VWC3 Third Submittal Response

PROJECT: Village at Westerly Creek III (DA-1639-01, Case # 2009-4001-02)

Below are my responses to the Second Submission Development Review comments.

Re: Second Submission Review – Villages at Westerly Creek Phase 3 – Site Plan – Comment Response

DRAWING SET	
100% SCHEMATIC DESIGN	
SET ISSUE DATES:	
SUBMITTAL	16-0916
SCALE	AS SHOWN
SHEET TITLE: BLDG 09

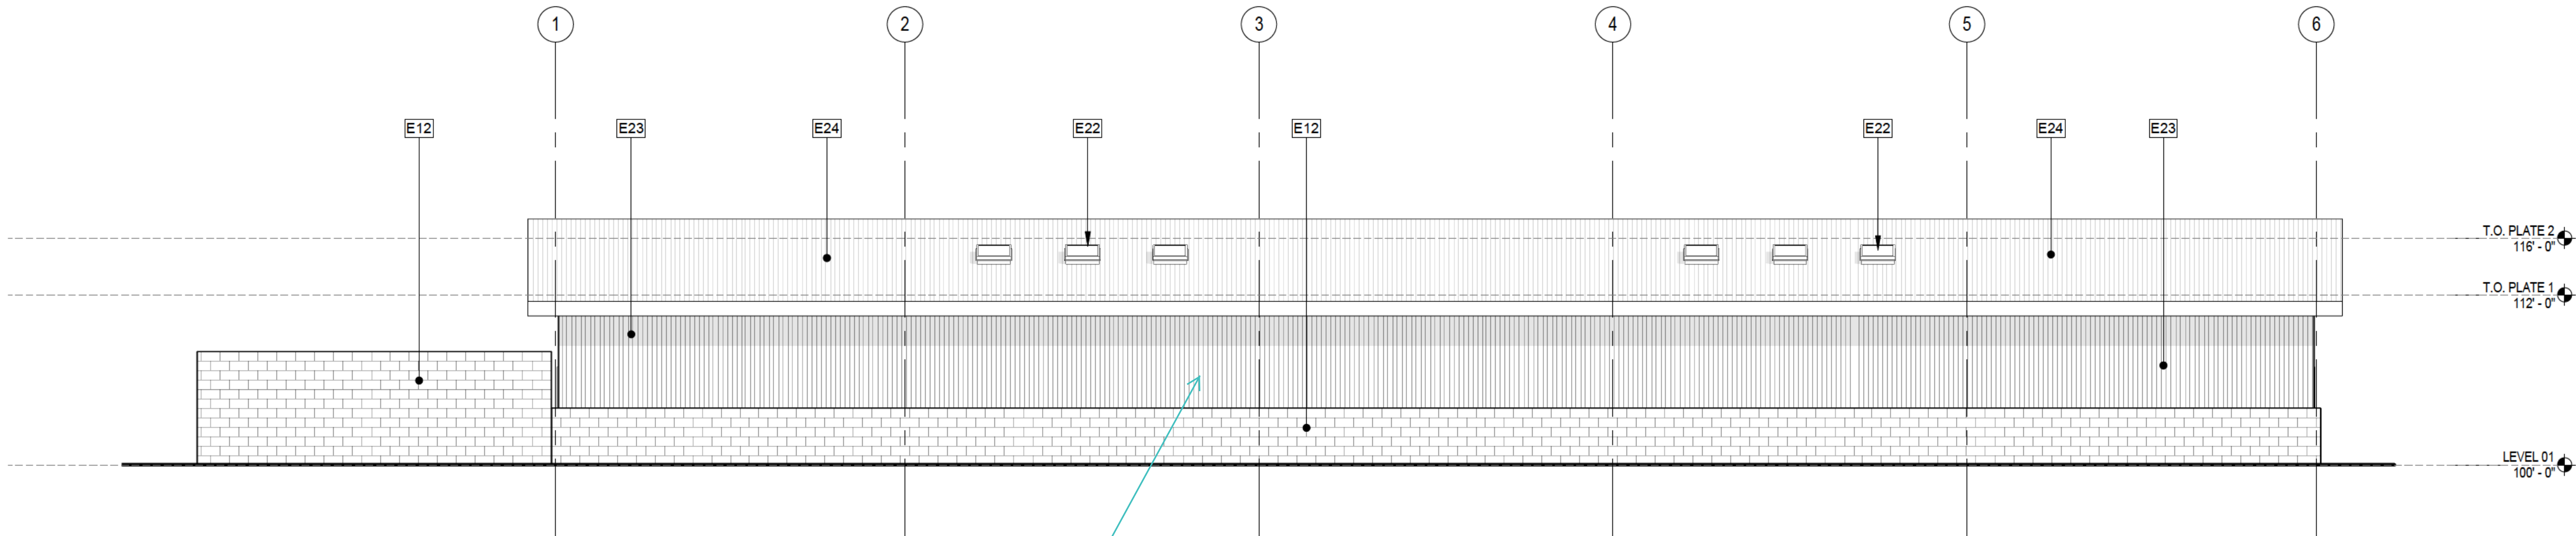
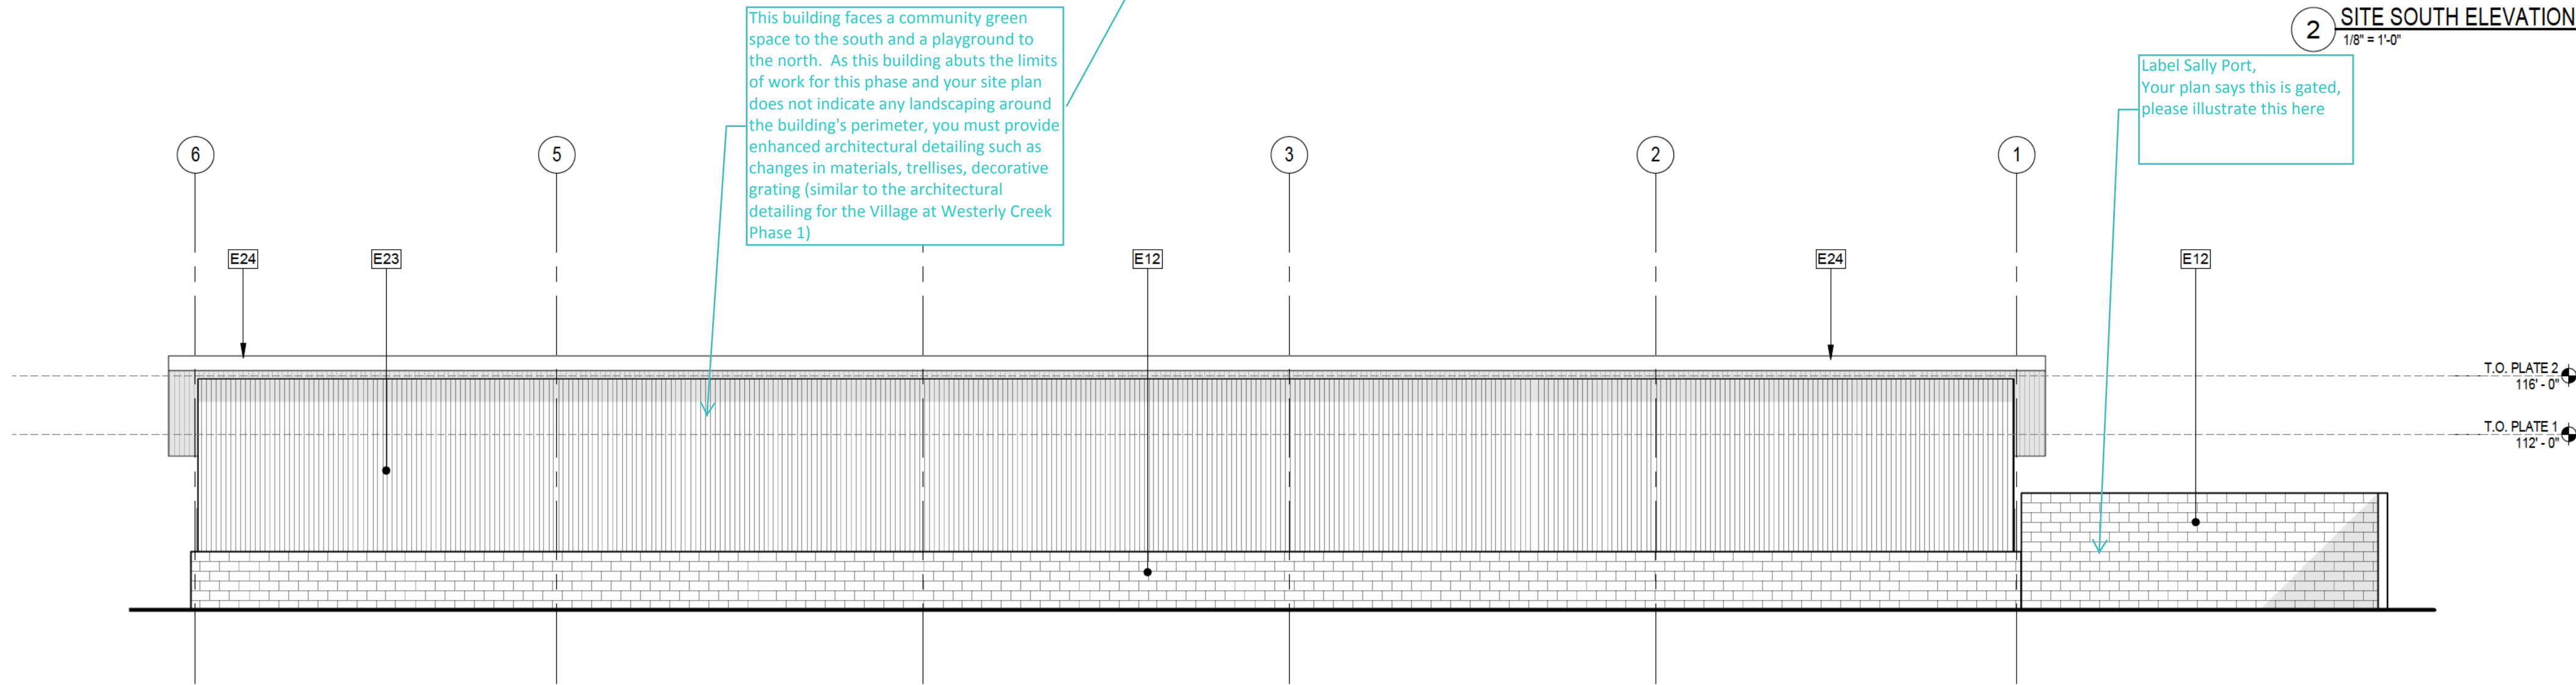
This building faces a community green space to the south and a playground to the north. As this building abuts the limits of work for this phase and your site plan does not indicate any landscaping around the building's perimeter, you must provide enhanced architectural detailing such as changes in materials, trellises, decorative grating (similar to the architectural detailing for the Village at Westerly Creek Phase 1)

Label Sally Port, Your plan says this is gated, please illustrate this here

The Utility Plan Knox Box label would indicate the entrance door is on the west end. Please verify.

- B. A waiver to remove all garage doors has been requested.
 - C. Enhanced architectural details have been added to Building 9 in the form of colored metal panel and a split face architectural block wainscot around the entire building.

- D. The sally port and gate at the Maintenance Building 9 has been clearly labeled and gate is shown on the elevation.
- 6. Other site Planning and Technical Issues
